PALATINE, ILLINOIS
PALATINE ROAD
M.P. 26.04
HARVARD SUBDIVISION
D.O.T.#176 938A
D.O.T.#176937T

Designed: 08-06-09 INSTALL CANTILEVER AND MEDIAN GATES FOR ROAD EXPANSION. Rec#: WO#: 87693 IS: /WSD / /JMM/JTB	REV. 11-15-02 UPGRADED CROSSING CONTROL AS PER THE PALATINE, IL CORRIDOR PROJECT REC. #11126 5-30-02 JJF JLK/WITT/WITT/JNM	MODIFICATION LEVEL		UNION PACIFIC QUALITY PRODUCTIVITY SAFETY SIGNAL DESIGN	DES: WITT.IND. DIG: WITT.IND. CHK: J.J.F. A.F.E. 34166 ID= HAR2604.8X	UNION PACIFIC RAILROAD EVANSVILLE, WISCONSIN TO CHICAGO, ILLINOIS C.T.C. CIRCUITS Office of Sr.AVP Engineering - Signal/TCO OMAHA NEBR.	DATE 3-21-00 SHEET 8 DWG 26.04 HAR
						Q.A. LAST LEVEL CHK'D.	CY				
						LAST LEVEL MOD. THIS TYP.	CK				
						LAST LEVEL BY DESIGNER.	CZ				
						CHANGED FROM TYP.? Y/N	Y

UNION PACIFIC RAILROAD
EVANSVILLE, WISCONSIN TO CHICAGO, ILLINOIS
C.T.C. CIRCUITS
Office of Sr.AVP Engineering - Signal/TCO OMAHA NEBR.

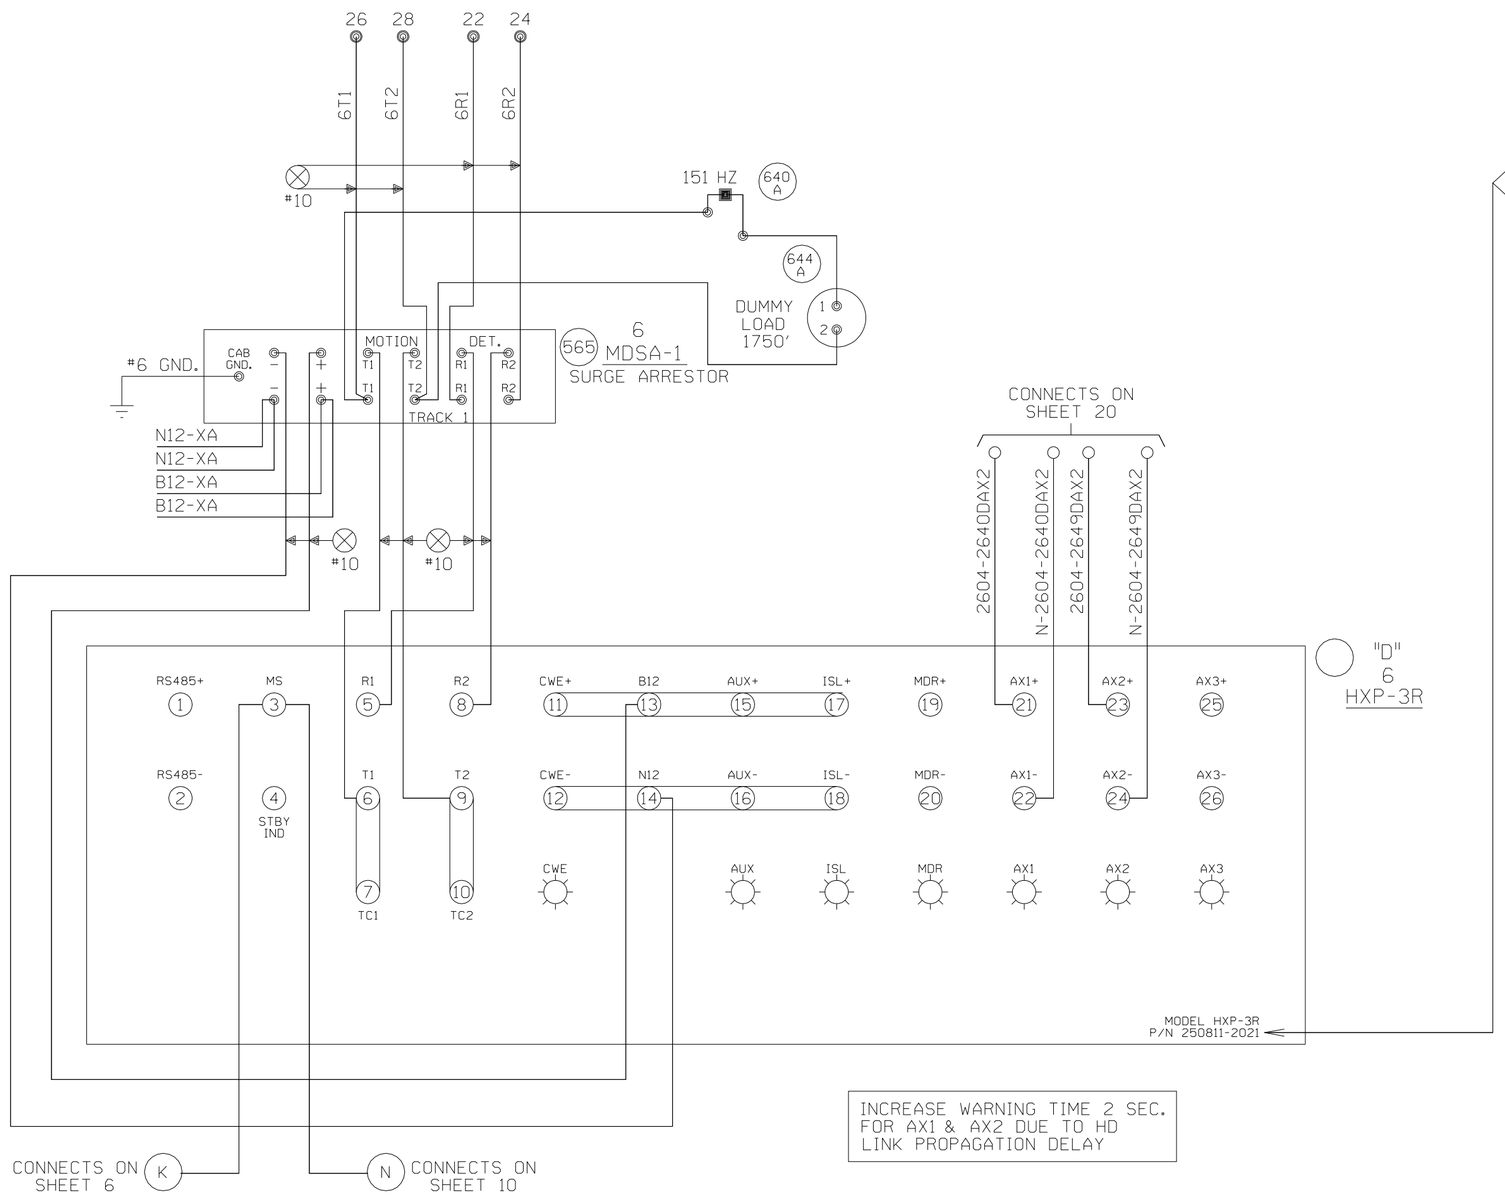
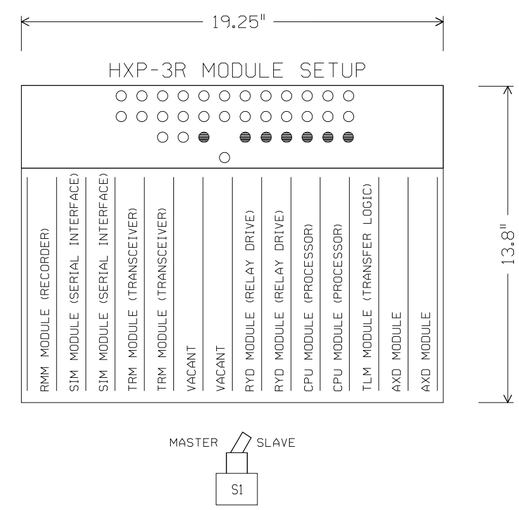
INCREASE WARNING TIME 2 SEC. FOR AX1 & AX2 DUE TO HD LINK PROPAGATION DELAY

DATE 3-21-00
SHEET 10
DWG 26.04
HAR

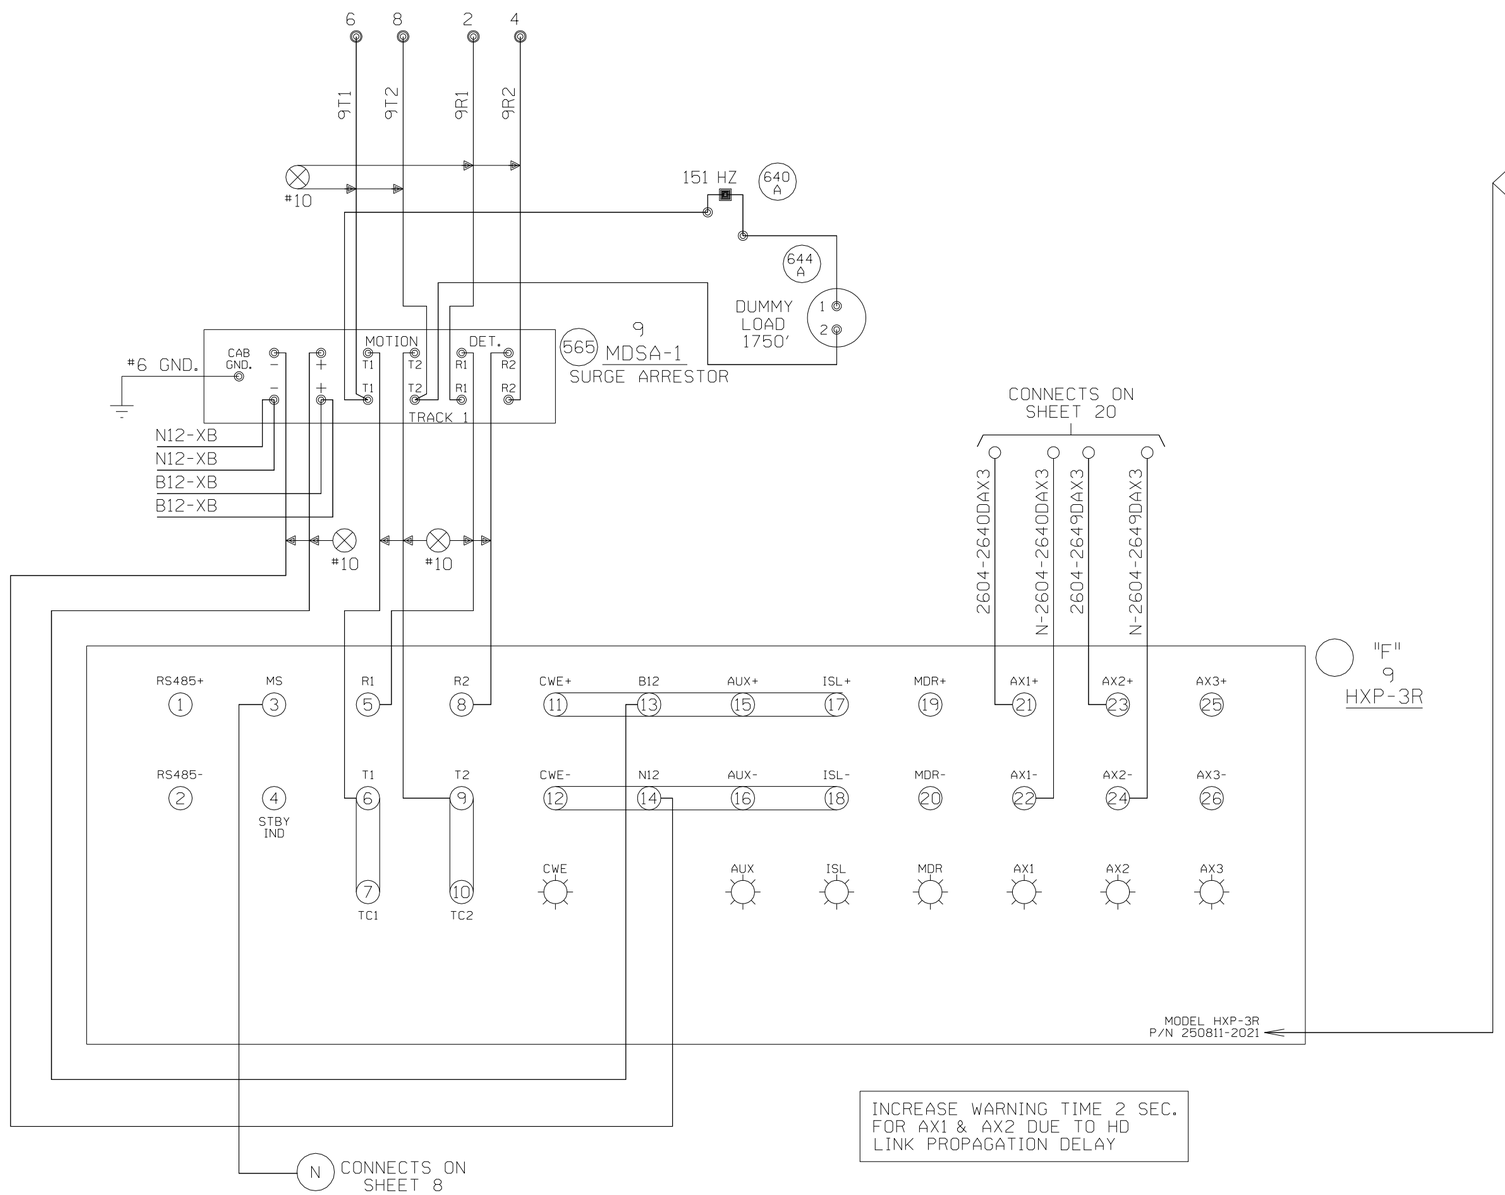
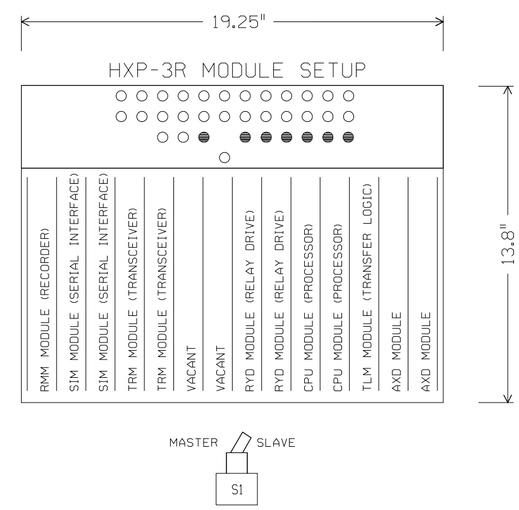
INCREASE WARNING TIME 2 SEC. FOR AX1 & AX2 DUE TO HD LINK PROPAGATION DELAY

DATE 3-21-00
SHEET 11
DWG 26.04
HAR

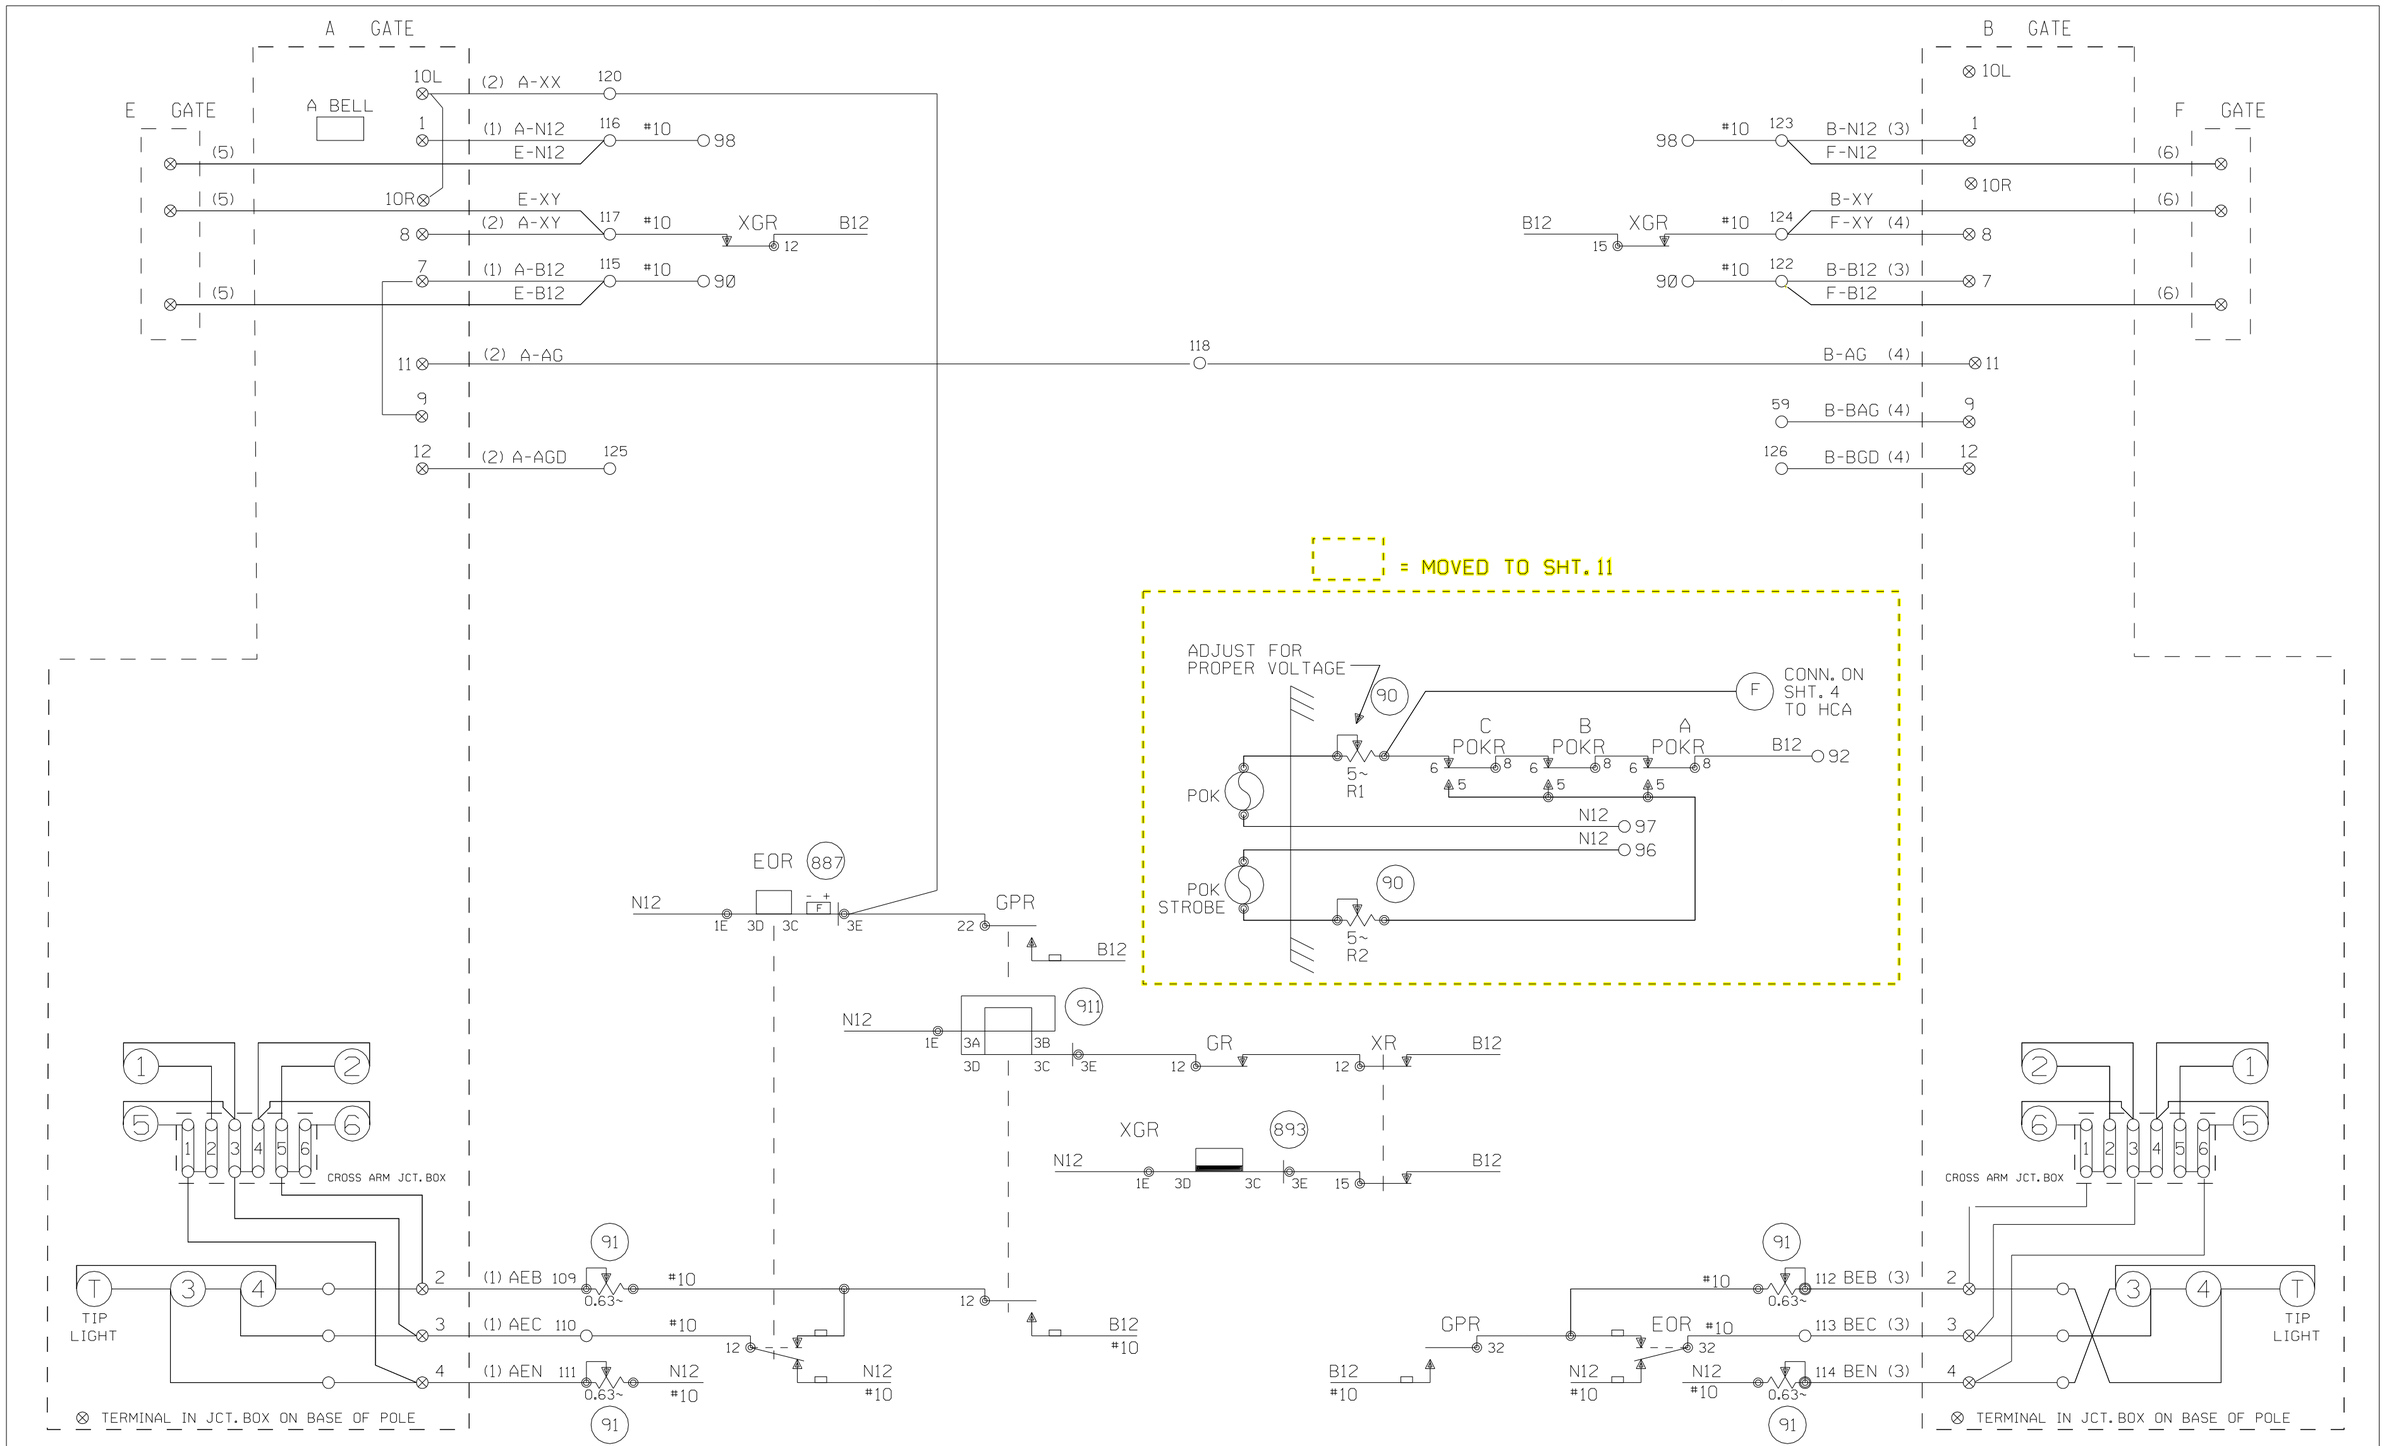
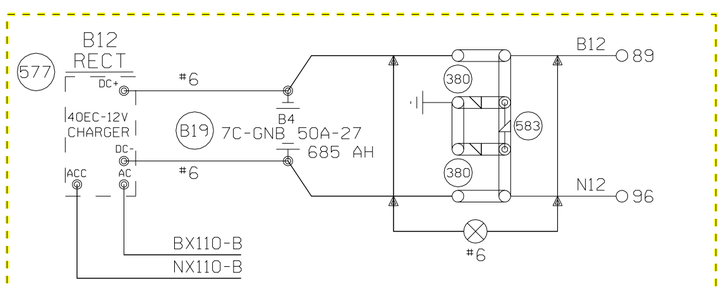
= MOVED TO SHT. 12

TO BE VOIDED

DATE 3-21-00
SHEET 12
DWG 26.04
HAR

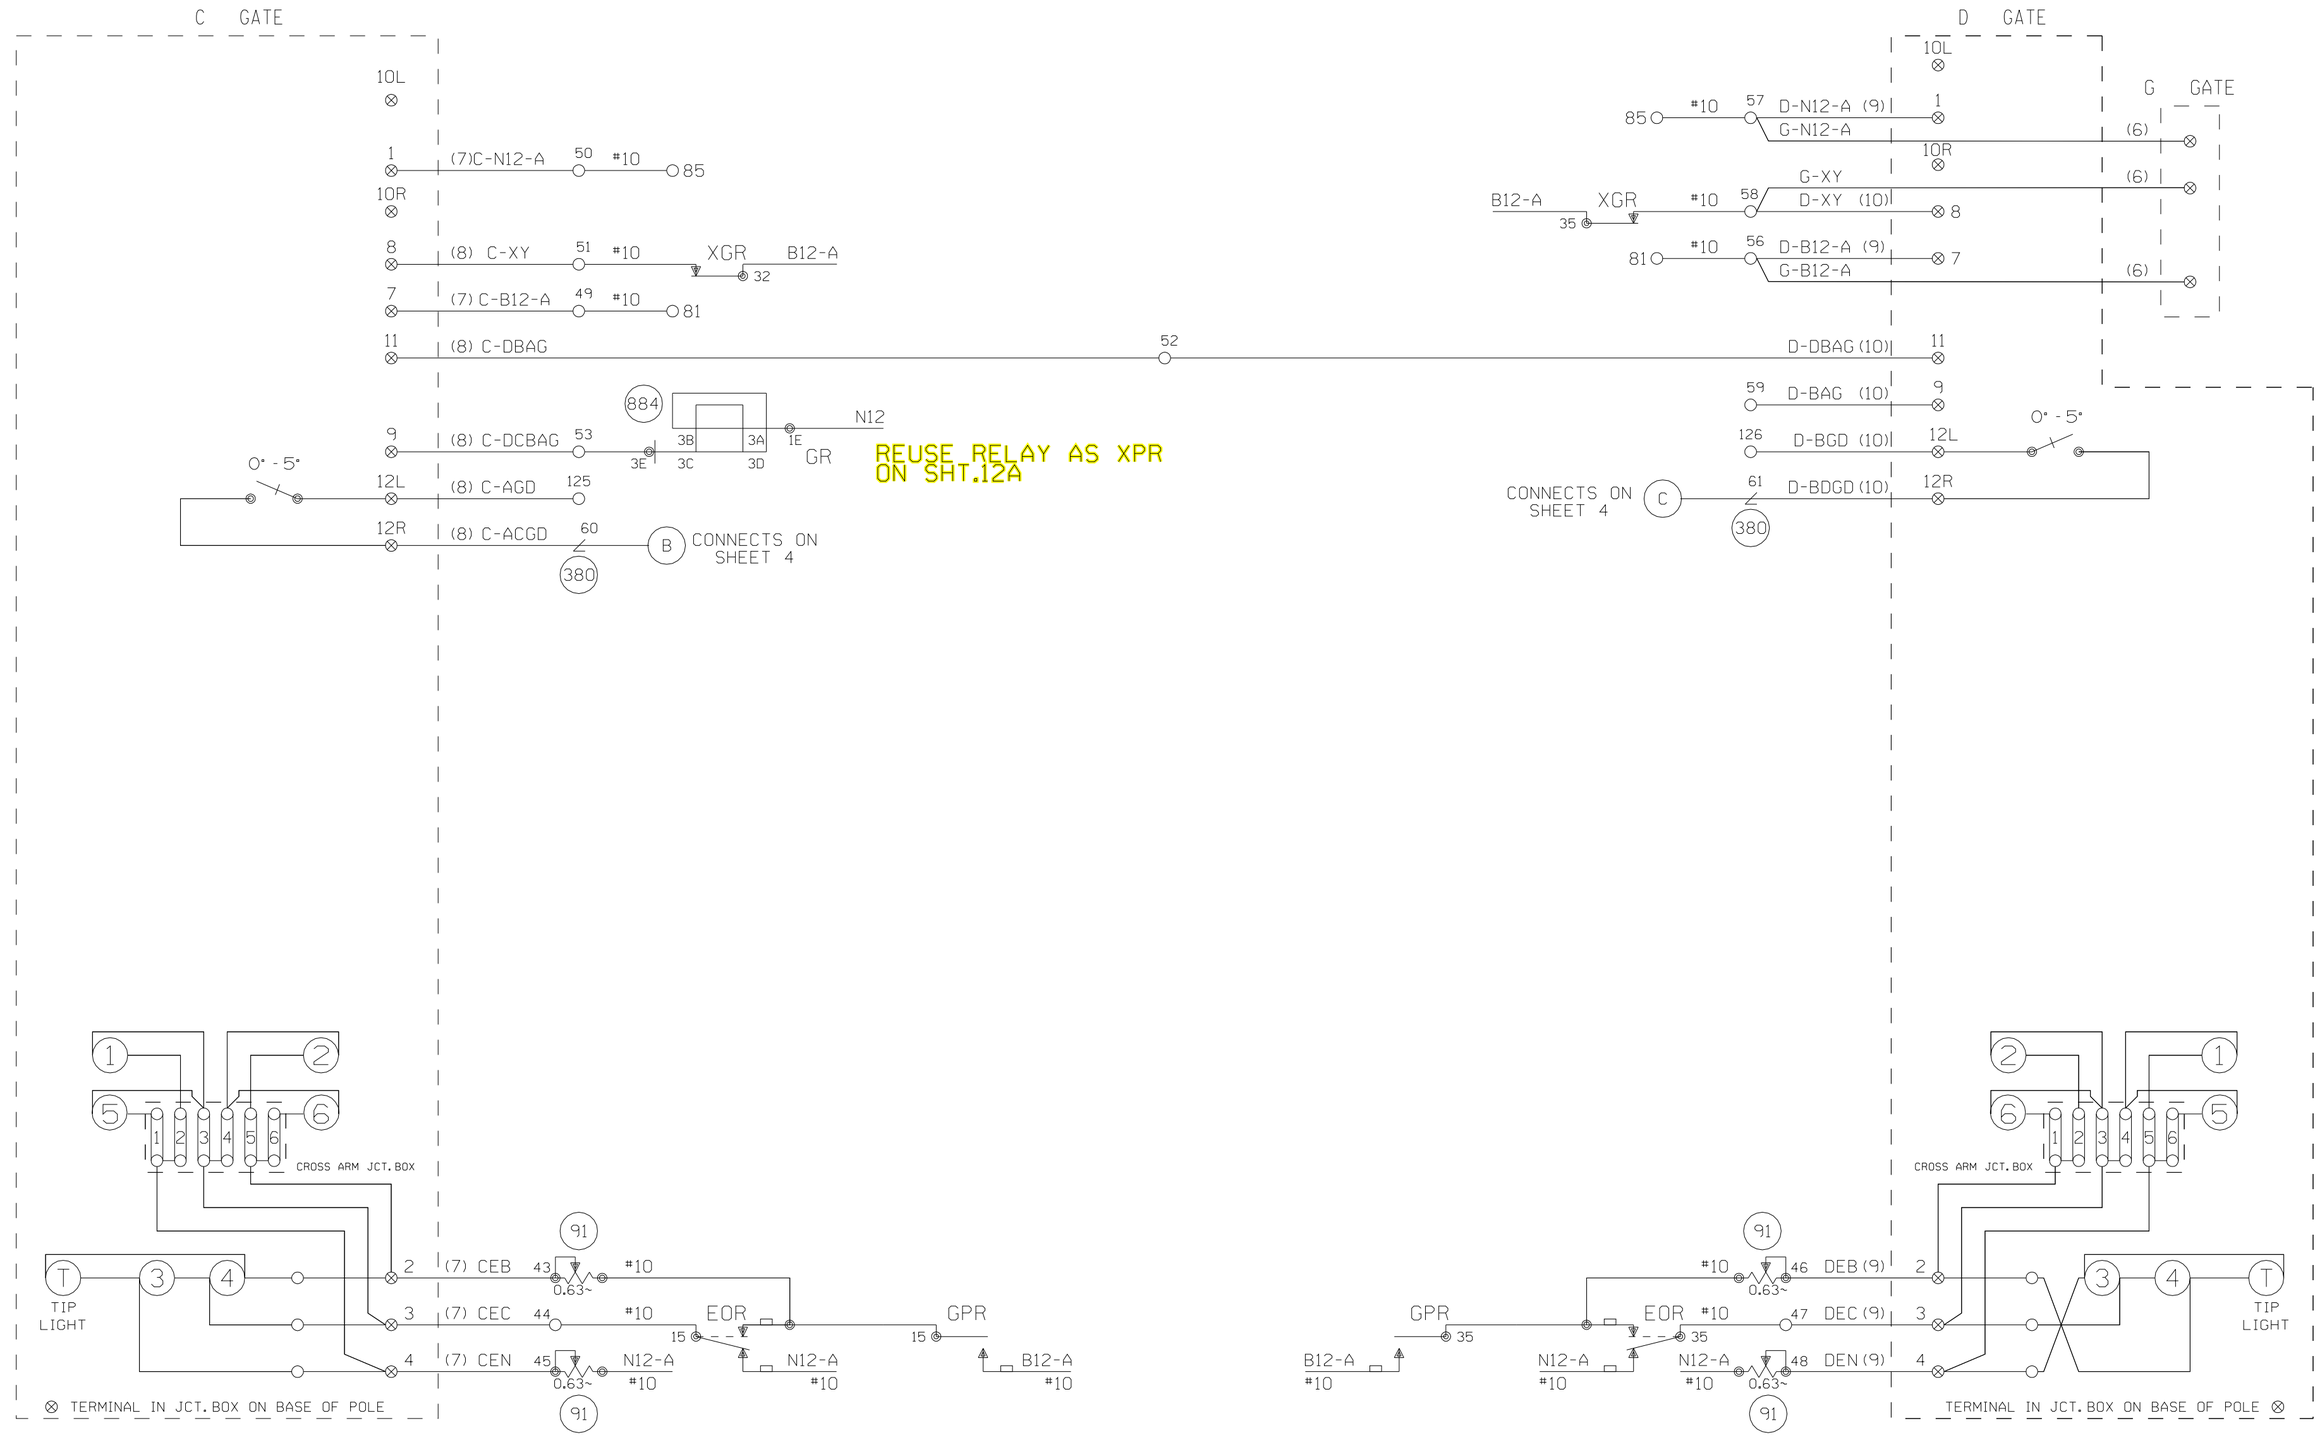
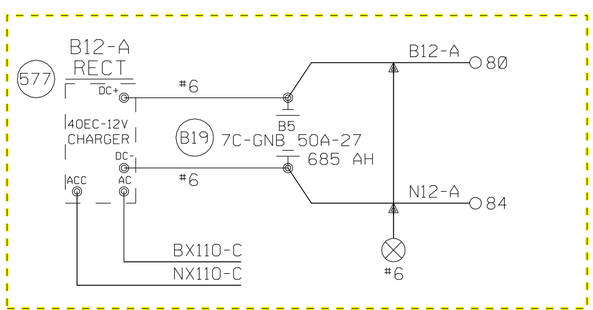
REUSE ON SHT. 12A

TO BE VOIDED
